No.: SB-SC-084 Date: 2021-04-08 Page: 1 of 4

SERVICE BULLETIN

MODEL AFFECTED:	SportCruiser / PiperSport operating outside EASA rules	
SUBJECT:	Substitution of Kuntzleman light	
AIRCRAFT AFFECTED:	All SportCruiser / PiperSport aircraft	
COMPLIANCE:	According to the owner's decision.

This Service Bulletin contains instructions how to replace Kuntzleman light for a SunRay light.

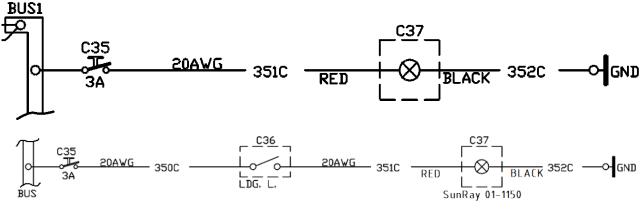
- 1. Set the **MASTER BAT** and **LDG L** switch to OFF.
- 2. Remove engine cowlings, disconnect positive (+) battery terminal (see MM, Chapter 11).
- 3. Remove the original landing light (see MM, Chapter 11).
- 4. Degrease the surfaces where the adhesive will be applied.
- 5. Stick the patch (002) from the outside with glue (008 or 009). See Fig. 1.
